RESPONSE TO FURTHER INFORMATION ITEMS 1b(i), (ii), (iii) and 4

DERRYCLARE WILD WESTRN PEATLANDS PROJECT

Client: Coillte Teoranta
September 25th, 2023
Project No: 10850

Plate 1 **Derryclare forestry access – looking north along R344**

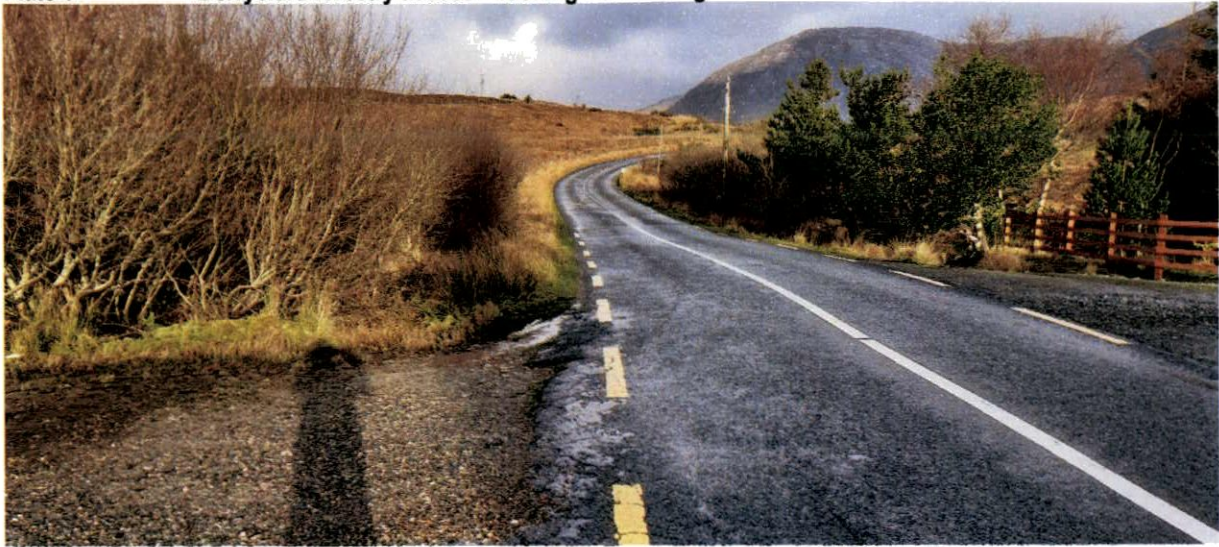
The sightlines have not been submitted in accordance with the required standards as set out in DM Standard 28 of the Galway County Development Plan 2022-2028.

The 70m visibility splays taken from a 2.4m setback are shown at the existing access junction on the R344 in the horizontal plane in Figure FI1. The figure, together with Plates 1 and 2, show that the only existing obstructions within the visibility splays are shrubs and hedging. It is confirmed that all of the land within the splays indicated are within the ownership of the applicant and that all existing shrubs and hedging will be cut and maintained to a maximum height of 0.25m.

Figure F11 Proposed visibility splays in horizontal plane (2.4m x 70m)

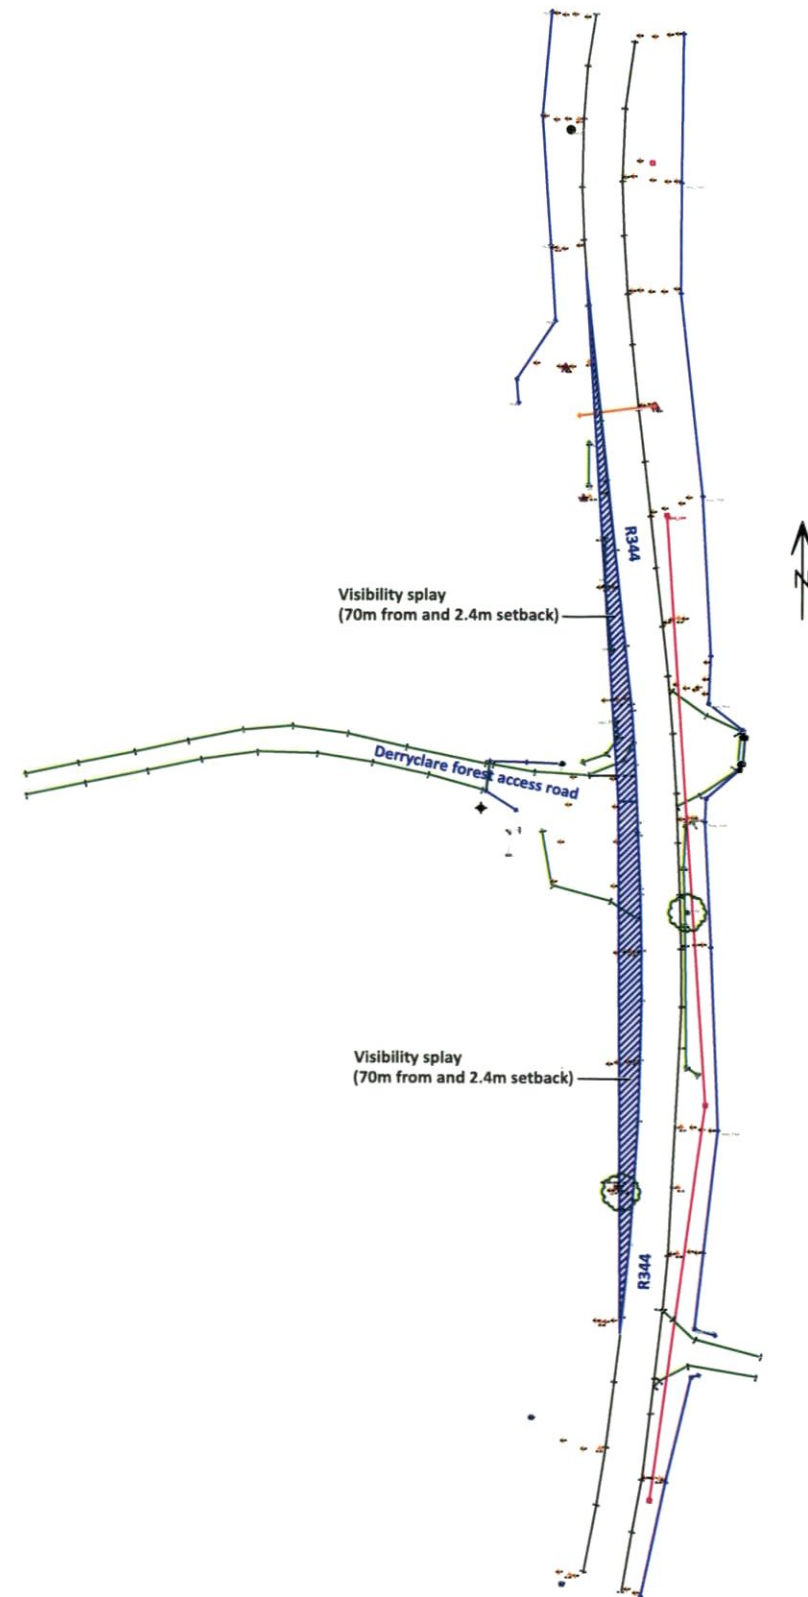
Please submit a revised site layout plan that indicates visibility of 70m in both directions from the proposed access to the site, from a 2.4m setback from the road edge, and measured along the near road edge, at an object height of between 1.05m from the access to 0.6m at the sightline distance.

Where works are required in order to facilitate the provision of adequate sight distances, lands within the sight distance triangles shall be within the control of the applicant and shall be subject of a formal agreement with the adjacent landowner which ensures certainty that the applicant is in a position to comply with the relevant condition and or standard.

It is confirmed that the lands within the visibility splays as indicated in Figure F11 are within the ownership of the Applicant who are in a position to provide the visibility splays indicated and also maintain them for the duration of the Proposed Development.

Figure F13 Autotrack assessment for large articulated HGV (15.4m long x 2.5m wide)

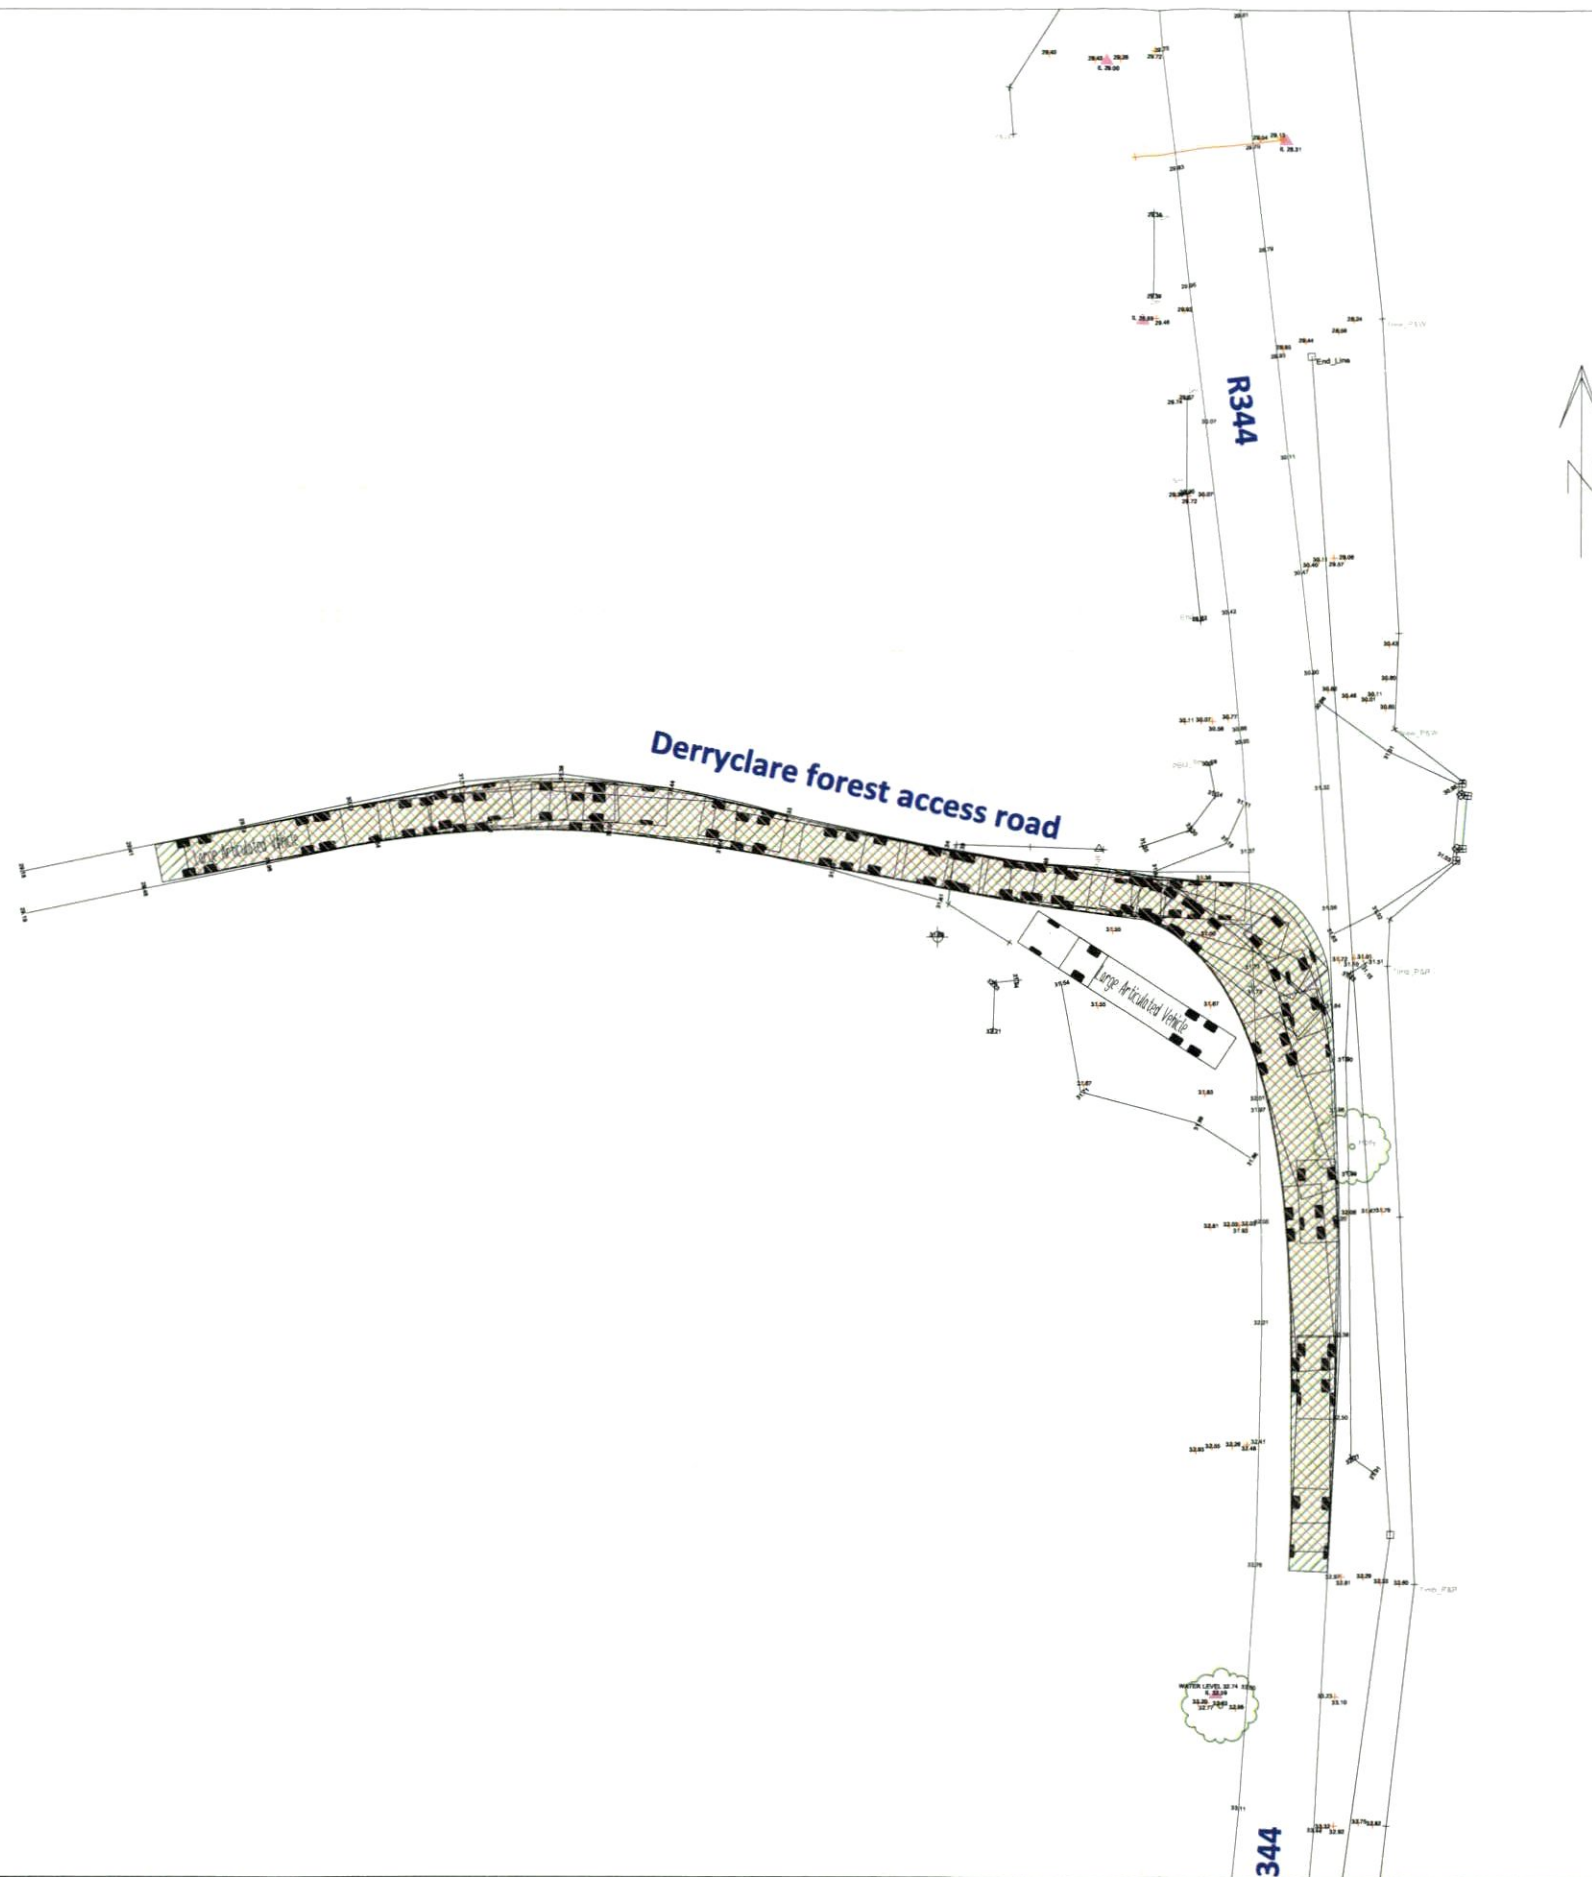
b. The applicant is requested to provide auto track analysis at the site entrance and within proposed internal layout

Autotrack assessment – An autotrack assessment for a large articulated HGV (15.4m long x 2.5m wide) exiting the junction is shown in Figure FI3. It is noted that this is an existing access, and these vehicles are currently accommodated at the junction. While based on the forecast traffic volumes it is very unlikely that 2 vehicles will meet at the junction, the figure demonstrates that an HGV accessing the site will be able to wait off the E344 if required
